**Entergy Nuclear Operations, Inc.**  
Pilgrim Nuclear Power Station  
600 Rocky Hill Road  
Plymouth, MA 02360

Response to NRC Request for Additional Information Related Repair of  
the Core Shroud Stabilizer Assemblies (TAC NO. MD4918)

LETTER NUMBER: 2.07.039

### Entergy Response to NRC Request for Additional Information Related to Repair of Pilgrim Core Shroud Stabilizer Assemblies (TAC No. MD4918)

**FIGURE 4: TIE ROD ASSEMBLY INSPECTION POINTS**

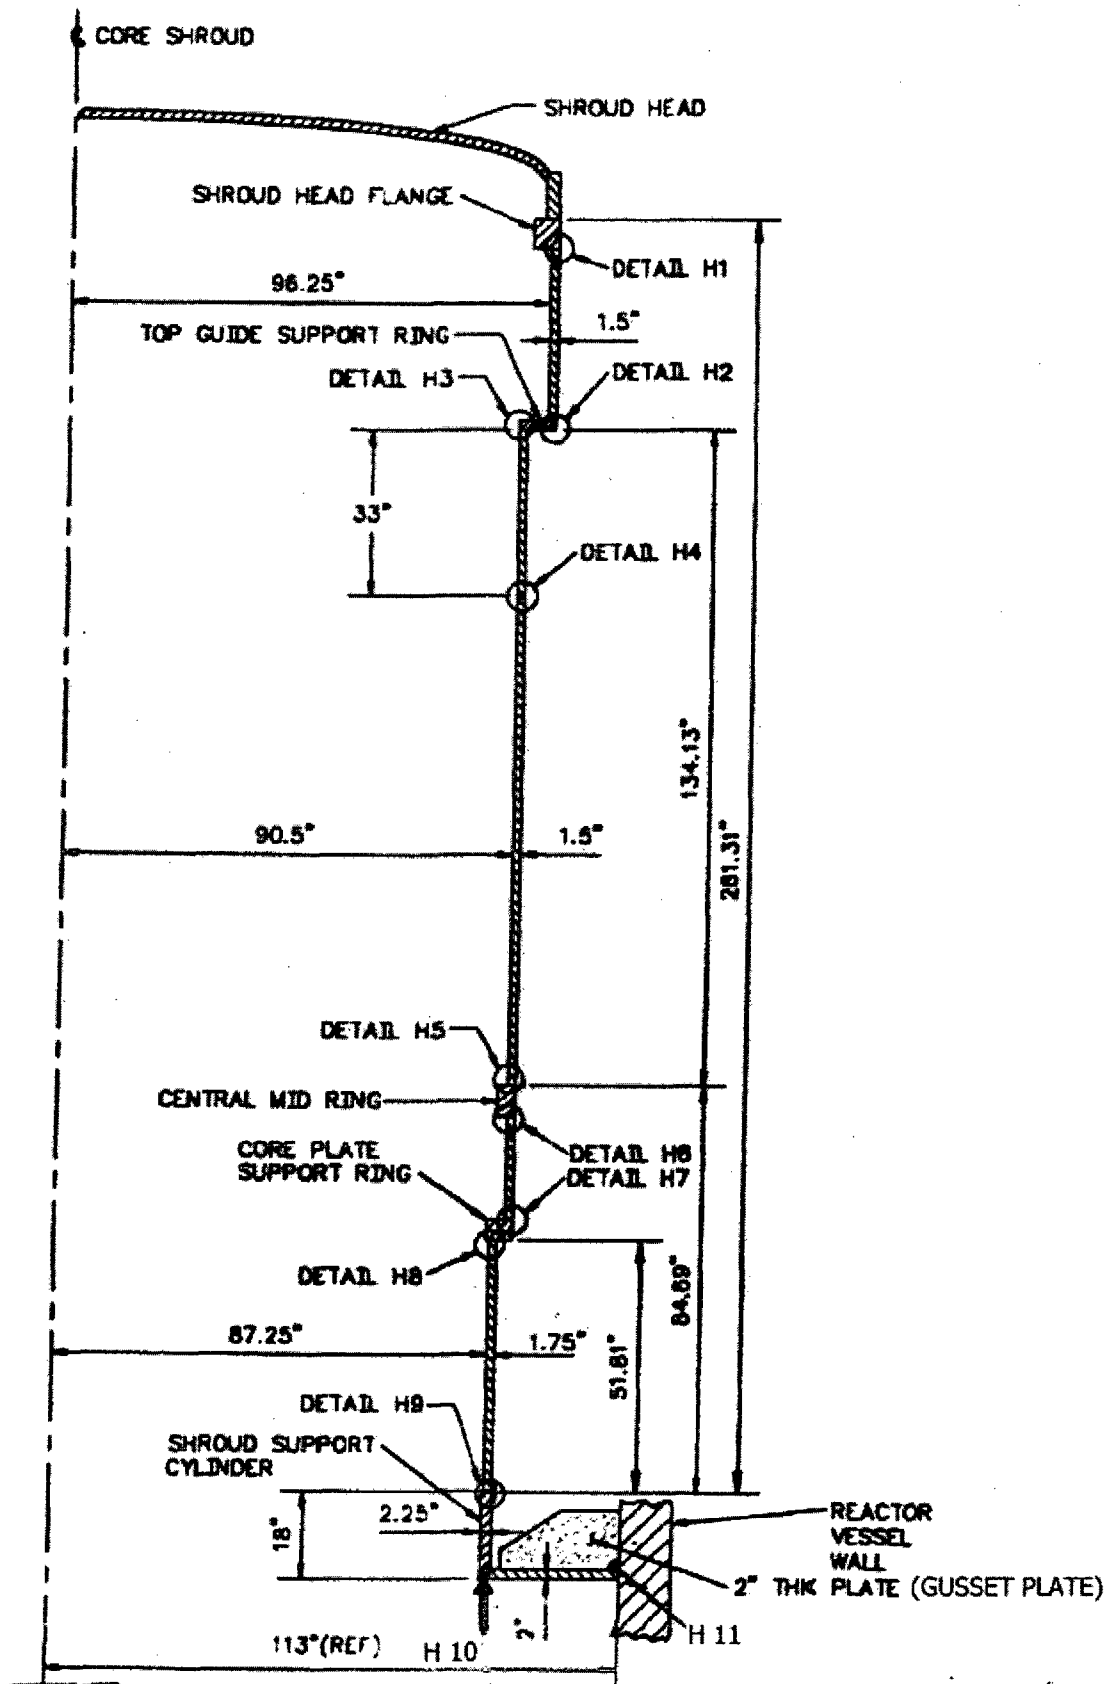
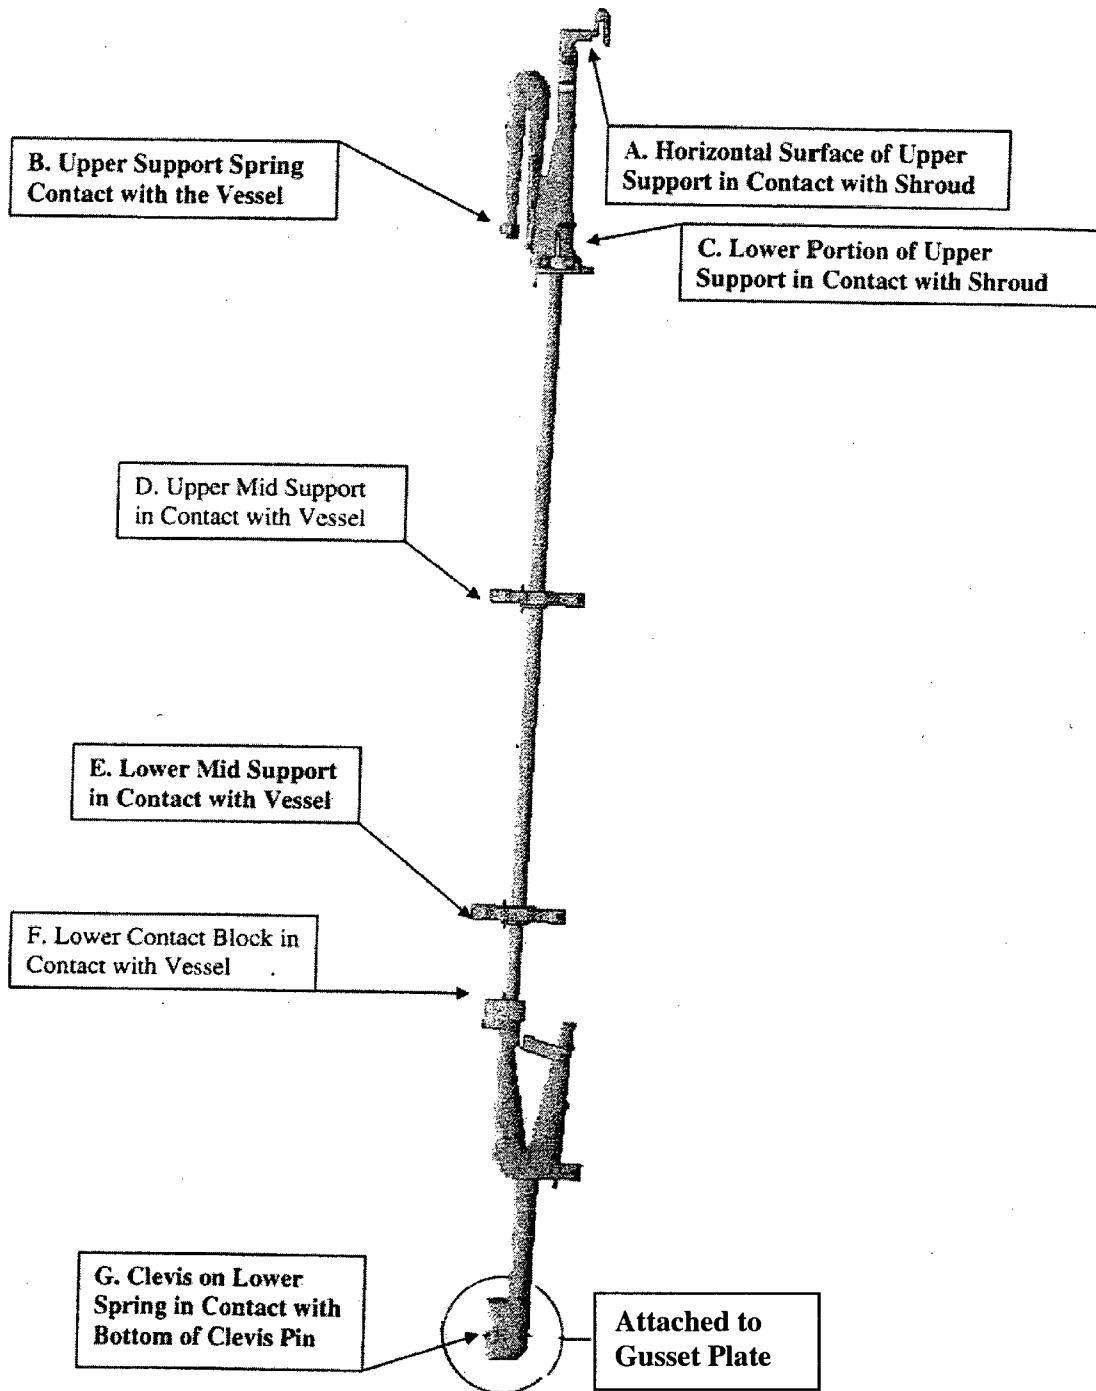
In the staff's safety evaluation dated May 12, 1995, for installation of the four sets of stabilizer assemblies and core plate wedges, the staff indicated that the reinspection plan should include the (4) gusset plate welds and the core shroud H11 weld because the integrity of these welds is essential to maintaining tie rod preload. The Regulatory Commitments in Attachment 2 to the March 22, 2007, letter does not include inspection of the gusset plate welds and core shroud H11 weld. The staff requests that the licensee

(a) either include the gusset plate and H11 welds in the reinspection plan or explain why reinspection is not necessary.

The following figures provide a cross section of the core shroud and the tie rod inspection points. As shown, the H11 weld is between the vessel and core support plate. The gusset plates are being inspected by EVT-1 methods during the current refueling outage. The inspection plan includes the locations necessary for assuring the structural integrity of the repair hardware. Future inspections will be performed consistent with the BWRVIP recommendations provided in BWRVIP-38 and BWRVIP-76-A.

Pilgrim has an installed (4) tie-rod system for the core shroud pre-emptive repair in the RPV. The main load path from the lower section of the tie-rods to the RPV wall is through corresponding gusset plates and connecting welds at 45°, 135°, 225° and 315°. These gussets have been inspected as follows:

Examination frequency complies with BWRVIP-38 guidelines. No relevant indications noted on these examinations.

In addition, Pilgrim has inspected 100% of the shroud support weld (top surface of H11) to the RPV wall in RFO15 with no relevant indications noted.
